<b>APPLICATION NO:</b> 19/02213/FUL		<b>OFFICER:</b> Miss Michelle Payne	
<b>DATE REGISTERED:</b> 7th November 2019		<b>DATE OF EXPIRY :</b> 2nd January 2020	
<b>WARD:</b> Park		<b>PARISH:</b>	
<b>APPLICANT:</b>	Mr D Richardson		
<b>LOCATION:</b>	1 Bath Mews, Commercial Street, Cheltenham		
<b>PROPOSAL:</b>	Rooftop extensions to 1 and 2 Bath Mews (revised scheme)

**19/02213/FUL Objection**

Existing Side Elevation (no.2)

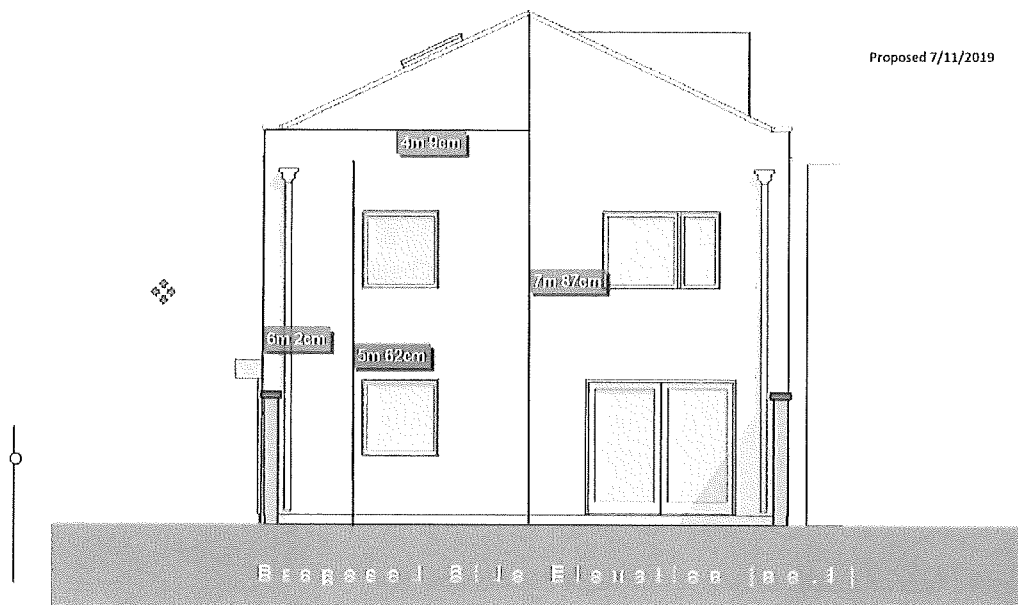
In first instance the nearest front elevation of the proposal is higher than existing by at least 400mm. **Overall height increase is 2.2 mtrs.** So there will be further unacceptable overshadowing and loss of light to various houses, in particular no's 9, 11 and 12 Victoria Retreat. The D and A statement only attempts to address "overlooking" and "building form". The D and A **does not address loss of light.**

**Fig A:** New proposal further exceeds maximum obstruction angle for both 9 and 11 Victoria Retreat, to the nearest rear ground floor windows.

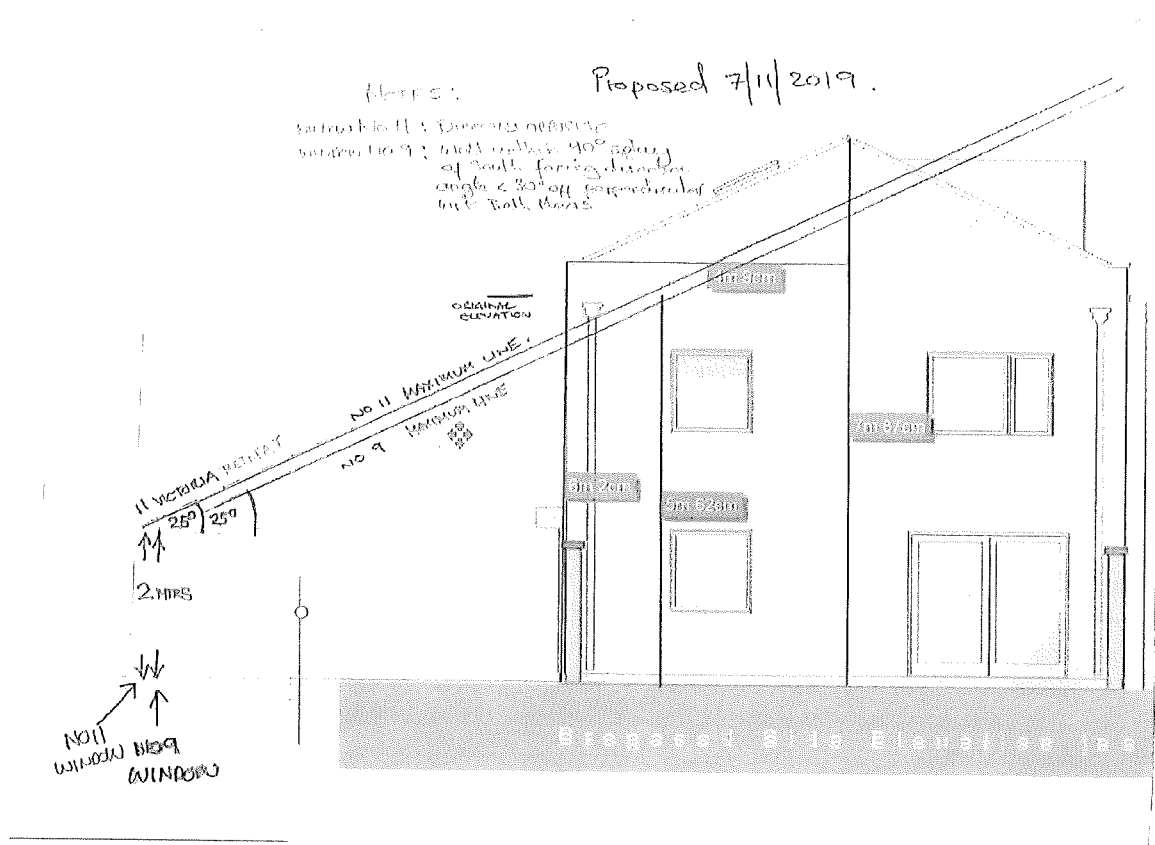
Aside from the fact the 25° is also breached for 9 Victoria Retreat in the buildings present form, the new proposals further increase height and so increase overshadowing and light loss. How is this to be judged an “acceptable loss”?

- The original build [06/01557/FUL], in respect of loss of light to rear ground window of 11 Victoria Terrace, is 20% beyond maximum obstruction angle [25°]. *“slight breach of the standard”* is likely a subjective position taken in 2006. It is a significant breach.
- This was and is “unacceptable” by all normal measure, yet Planning deemed this “acceptable loss” in 2006.
- New proposal now wants to build up 32% beyond max obstruction angle.
- Notwithstanding present overshadowing is unacceptable, Applicant wants to increase harm to Amenity of neighbour with a further 10% loss of light to the window that had already forcibly “donated” in 2006.
- The nearest front elevation **increases from 5.5 mtrs to 6 mtrs in height.**
- The over-all elevation **increases to 7.9 mtrs.**
